TMC SPECIFICATION

NO. S - 1126

GPT-40K HARMONIC SUPPRESSION (Special)

KIT-244A

SHEET 3 OF 5

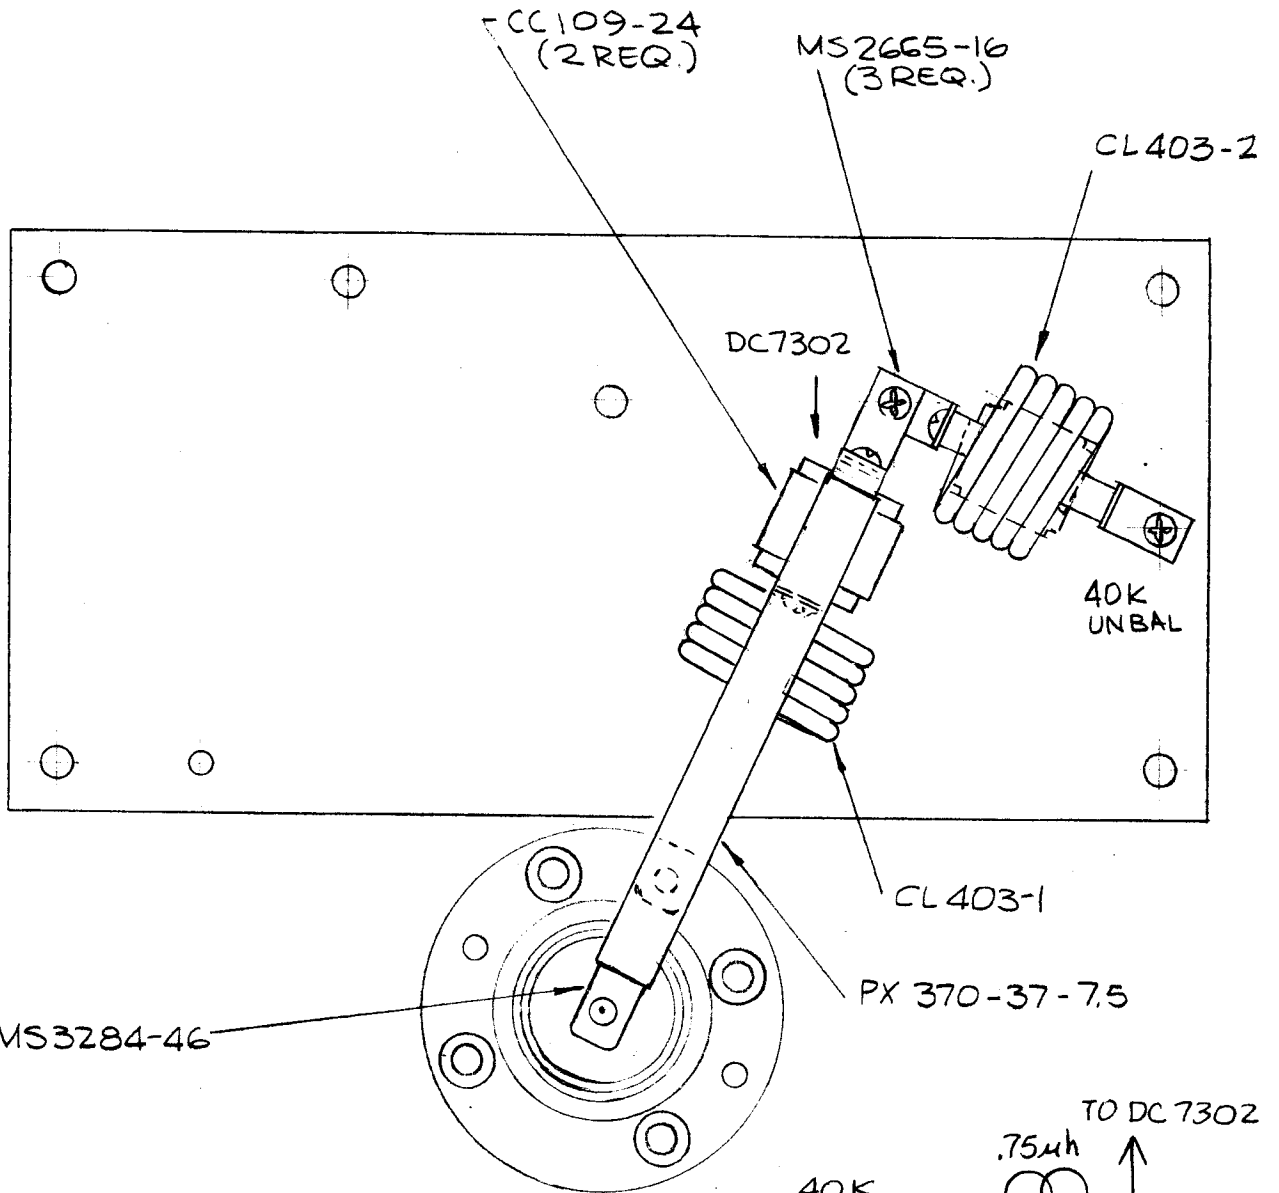
- D. Mount the CL-304-1 and -2, strap MS-3284-46 and brackets (MS-2665-16) Sheet 3.
- E. Attach NP-854 to a suitable conspicuous area on transmitter.
- F. Modification complete. Check and restore power to equipment.
